RE: Cooper's Hollow Subdivision

I have reviewed the application to divide RP06N45E058700 6 buildable lots with an average of 23 acres each.

Eastern Idaho Public Health gives preliminary approval of the application to develop this subdivision, Cooper's Hollow, based on the evaluation of the property. An evaluation for site specific areas will be required prior to issuing septic system permits for each lot. Individual subsurface sewage disposal systems may be allowed in accordance with IDAPA 58.01.03 and the Technical Guidance Manual for Individual Subsurface Waste Disposal. All current Idaho Rules must be met. Suitability criteria and required separation (horizontal and vertical) distances are to be maintained.

TEST HOLE INFORMATION

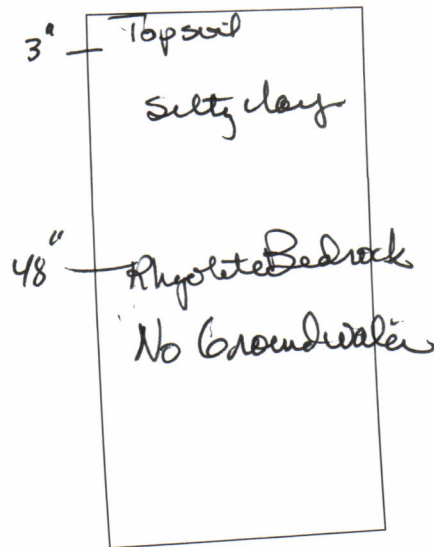
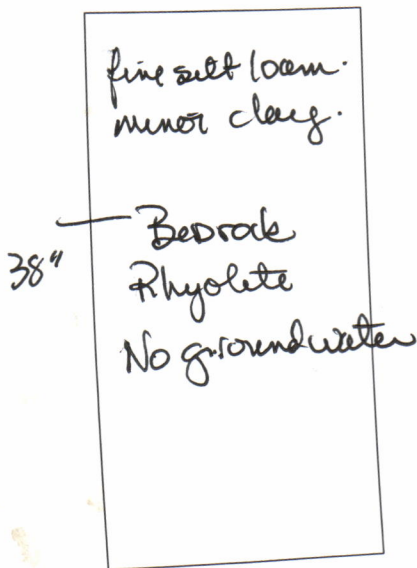
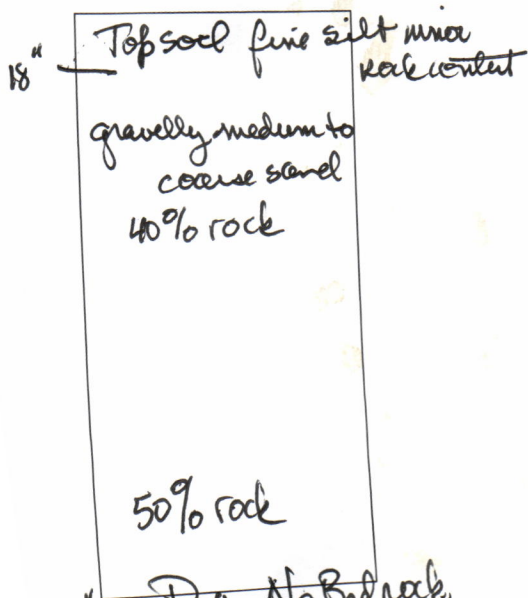
I observed evaluated soil horizons in three basic areas of the parcel. The western area (proposed lots 1 & 2) is relatively flat (minor slope) and shows the following soils to 120 inches below grade: 0-18 inches top soil fine silt with minor rock content, 18-120 inches gravelly medium to coarse sand with minor fines and 40-50% rock content. Clasts are 1" to 10" diameter rounded clasts increase to up to 18" clasts at depth.

The eastern area (proposed lots 3, 4, 5) is a hill with slope on all sides ranging from 8 to 15%. The test hole shows soils: 0-38 inches of fine silt with minor clay. Rhyolite bedrock was encountered at 38 inches below grade. Due to the lots being larger than 5 acres subsurface wastewater systems will be able to be excavated to a maximum of 14 inches and will have a cap of fill to reach 12 inches over the top of the drainfield medium. There is ample room for the systems and replacement systems. Trenches will be required to follow the contour of the slope.

The proposed area being considered for lot 6 has some areas of extreme slope and rhyolite bedrock is exposed at the surface. Areas with exposed bedrock and slope over 45 degrees are not suitable for subsurface wastewater disposal. An area that appeared to have been farmed at some point showed soils 0-3 inches of silty topsoil, 3-48 inches of silty clay, Rhyolite bedrock encountered at 48 inches. This area is large enough and the soil is deep enough to support waste disposal system excavated to 24 inches depth.
